South Texas Project
Units 3 and 4
Docket Nos. 52-012 and 52-013
Response to Request for Additional Information

02.05.02-28, Supplement 1

RAI 02.05.02-28, Supplement 1

Figure 1. Comparison of rock seismic hazard curves for several response spectrum frequencies (peak ground acceleration (PGA) and 25, 10, and 1 Hz) from the STP FSAR and the three hypothetical Gulf Coast Mmax distribution cases.

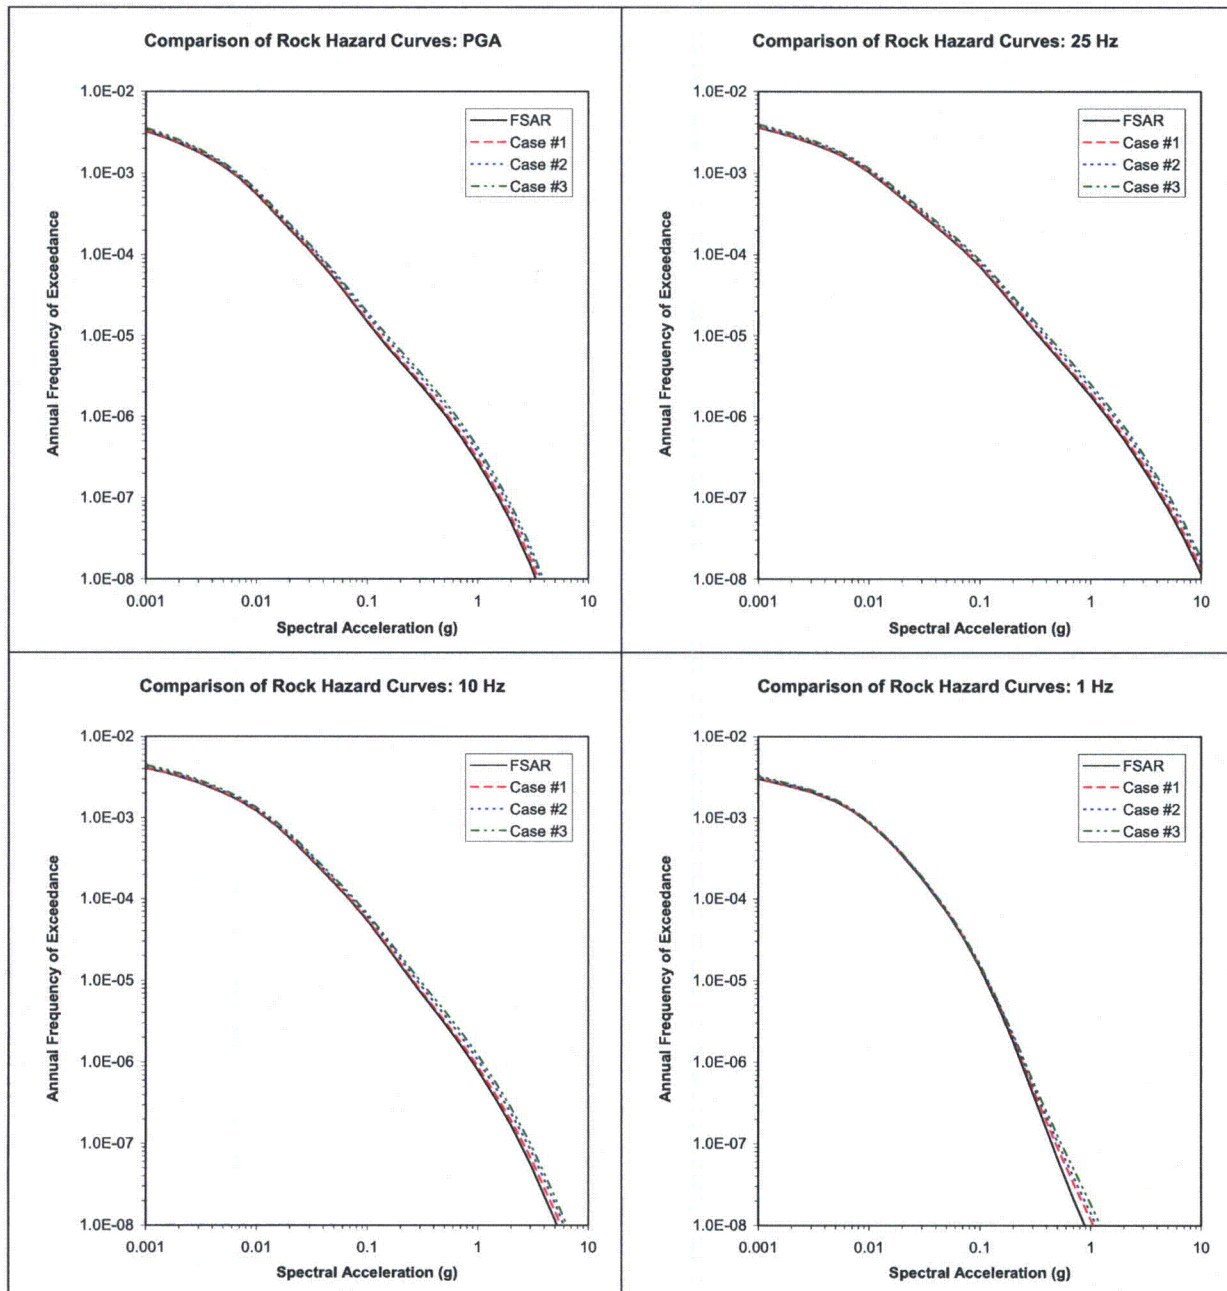
During a public teleconference with the NRC Staff on April 6, 2010, STPNOC agreed to perform a sensitivity study that applies the initial, preliminary Mmax distribution suggested for updating the EPRI-SOG Gulf Coastal Source Zones (GCSZs). Preliminary results of the sensitivity study were discussed with the NRC during a May 12, 2010 public teleconference and STPNOC agreed to submit the results of the study to the NRC. The requested information is being provided as a supplemental response to RAI 02.05.02-28 (STPNOC Letter U7-C-STP-NRC-100057 (ML100770389) dated March 15, 2010).

However, during a public telephone conference with the NRC Staff on April 6, 2010, the NRC requested that STPNOC perform a sensitivity analysis to investigate the impact that the use of this preliminary Mmax distribution would have on the ground motion response spectrum (GMRS) for the STP 3 & 4 site. Specifically, the NRC requested the following three different cases be analyzed (see Table 1):

Comparisons between the hard rock PSHA results for the STP COLA and the three hypothetical Mmax distribution sensitivity cases, and for several response spectrum frequencies, are shown in Figure 1.

The results for Case 1, which considers the September 2006 earthquake only in the zones where it occurred, show only 0 to 3% GMRS increases in the 0.5 to 100 Hz (PGA) frequency range. This comparison between the Case 1 results and the COLA GMRS quantifies the impact of the hypothetical Mmax distribution requested by the NRC on the STP 3 & 4 GMRS.

Figure 2. STP 3 & 4 FSAR and hypothetical soil GMRS corresponding to the values taken from Table 2. Also shown is the horizontal site-specific SSE response spectrum (STP 3 & 4 FSAR Figure 3H.6-1). All spectral accelerations are for 5% critical damping.

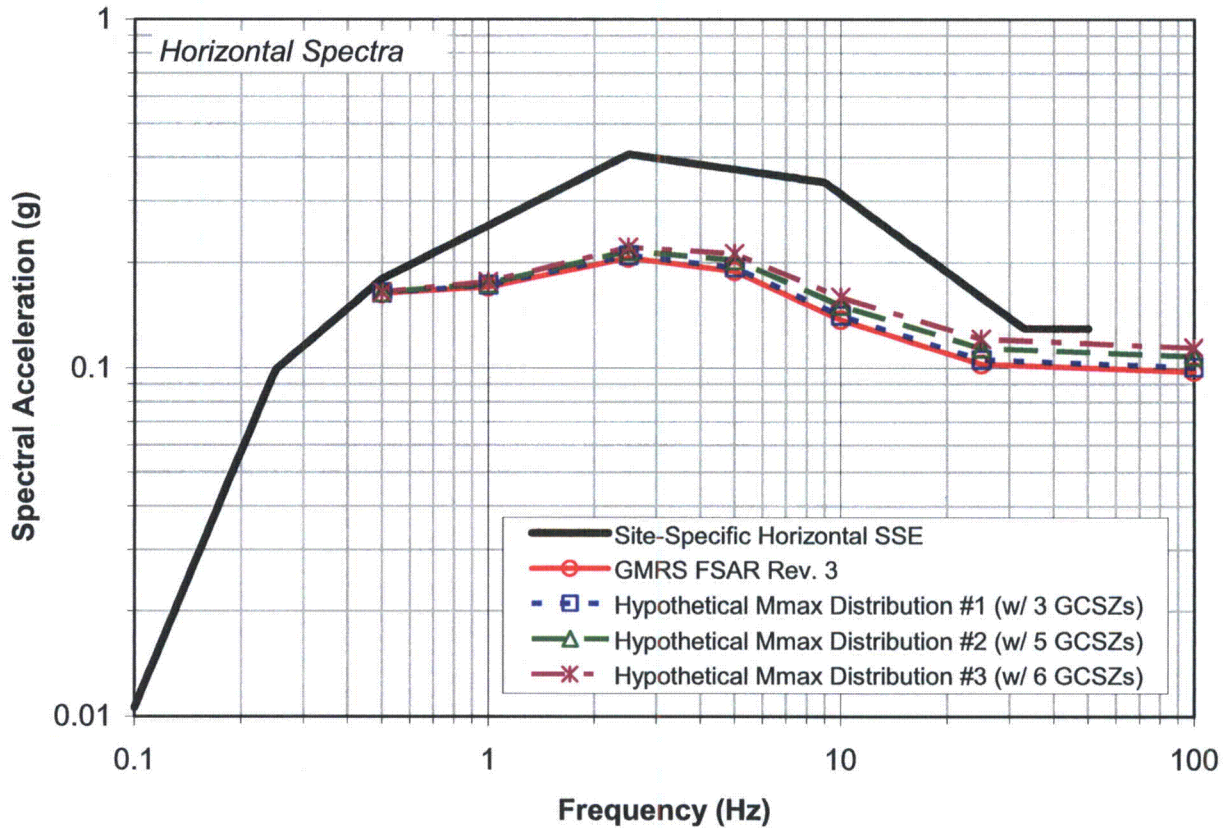
GMRS response spectral values derived, using the methodology recommended in RG 1.208, from the 10^{-4} and 10^{-5} hard rock PSHA values, multiplied by the frequency-dependent site-specific amplification factors used to develop the original STP 3 & 4 FSAR GMRS, are listed in Table 2 and shown in Figure 2.

The Case 2 and 3 sensitivity results depart further from regulatory guidance and have higher GMRS values, but all three sensitivity analysis cases result in hypothetical soil GMRS values that are below the site-specific horizontal SSE response spectrum as shown in Figure 2.

For these reasons, STP believes there is no safety impact identified in the evaluation of the differences between STP's updated Mmax distributions for the GCSZs and the three hypothetical cases studied. Therefore, the update of the Mmax distribution as described in STP 3 & 4 FSAR Subsection 2.5S.2.4.3 and implemented in the development of the GMRS in STP 3 & 4 FSAR Subsection 2.5S.2.6 is appropriate and reasonable.
